DUANE ARNOLD ENERGY CENTER

AMENDMENT TO FACILITY OPERATING LICENSE

Amendment No. 48
License No. DPR-49

SUPPORTING AMENDMENT NO. 48 TO LICENSE NO. DPR-49

DUANE ARNOLD ENERGY CENTER
IOWA ELECTRIC LIGHT AND POWER COMPANY
TECHNICAL SPECIFICATIONS
DAEC NUCLEAR PLANT STAFFING
FIGURE 6.2-1

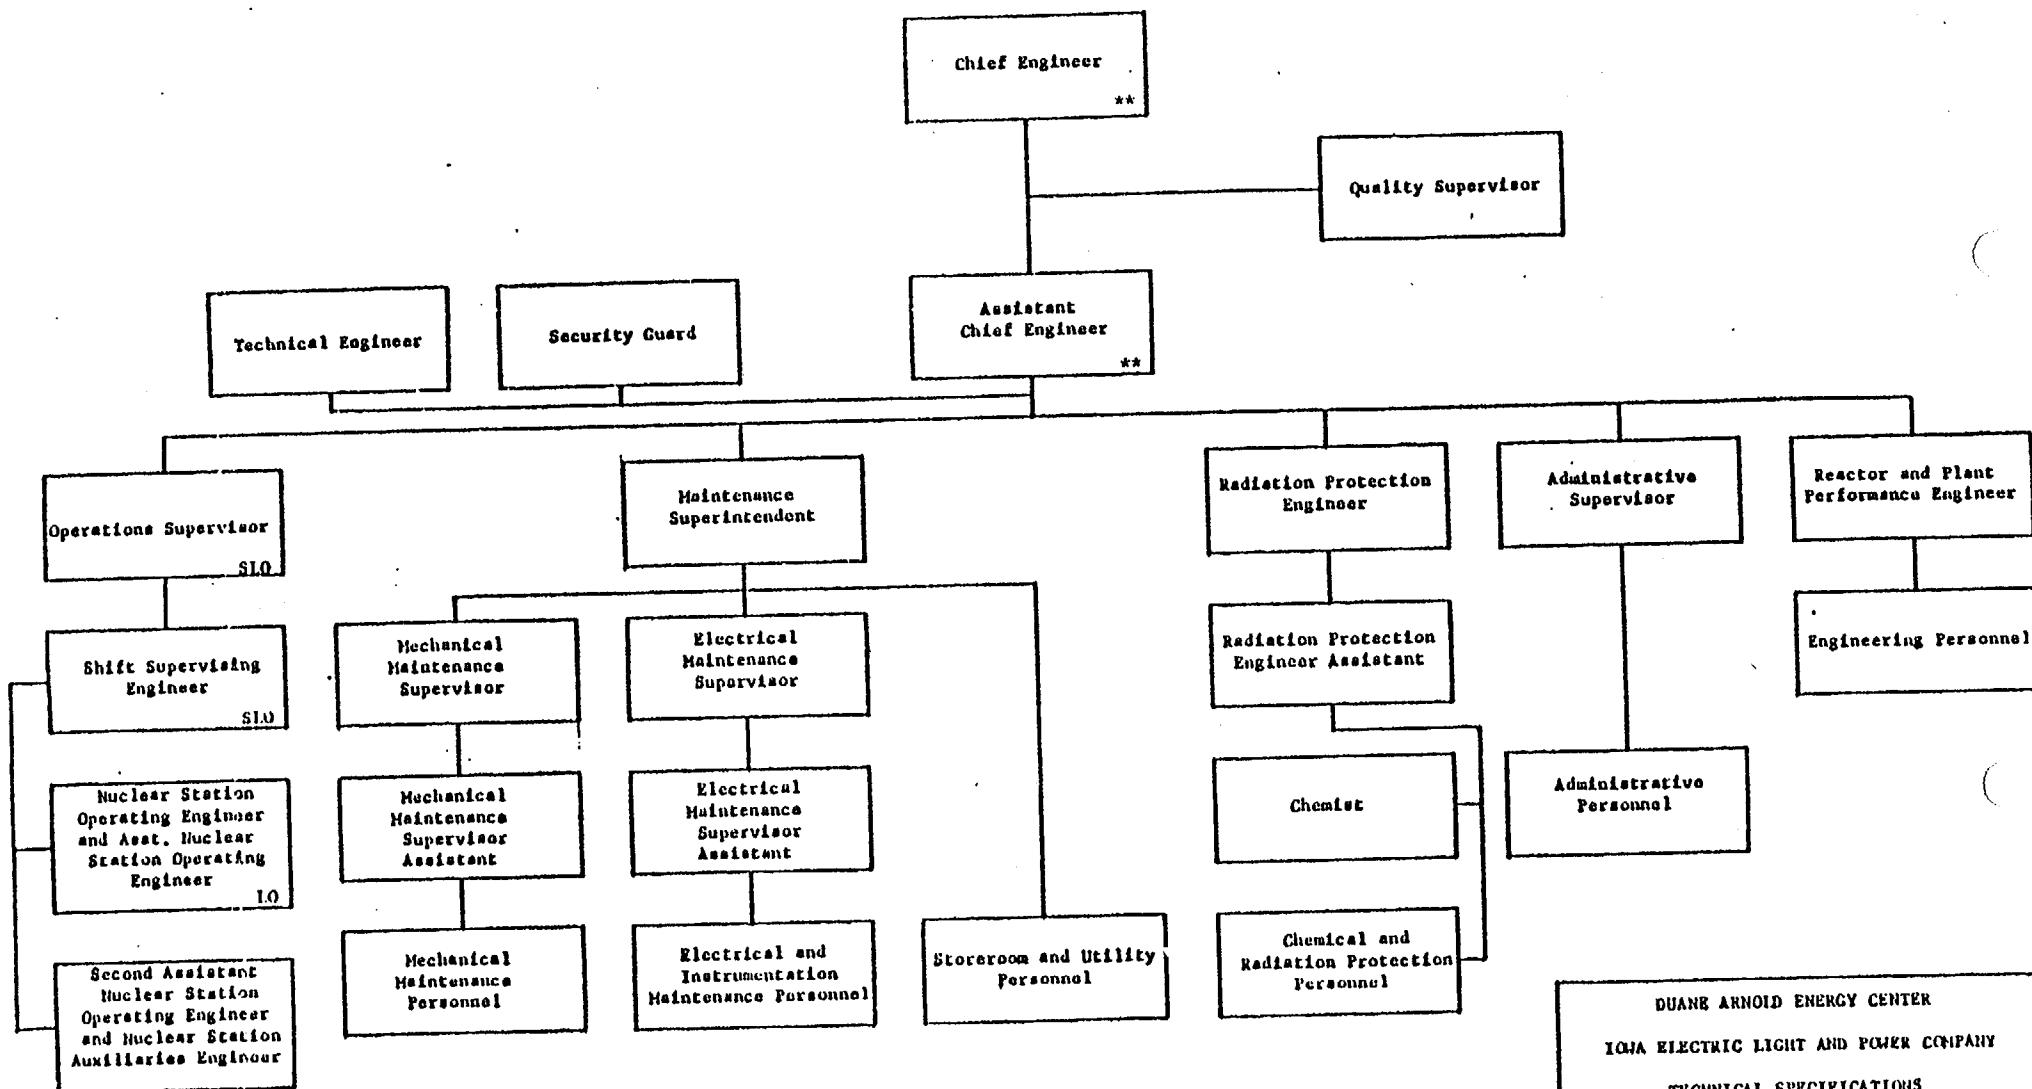
By letter dated July 7, 1977, the licensee requested to delete the asterisk from the positions described above in figure 6.2-1 and to delete the notation to which the asterisk refers. As stated above, this change is an omission that should have been made in Amendment No. 12. The change has no safety significance. Deletion of this reporting requirement does not adversely affect the quality of DAEC supervisory personnel since the qualifications of plant members and replacements must meet or exceed the qualifications referenced for comparable positions in ANSI N18.1-1971, as noted in Specification 6.3.1.

As discussed in Section 1.2 above, there is no safety significance to this change. The change is necessary to correct an error in the Technical Specifications.
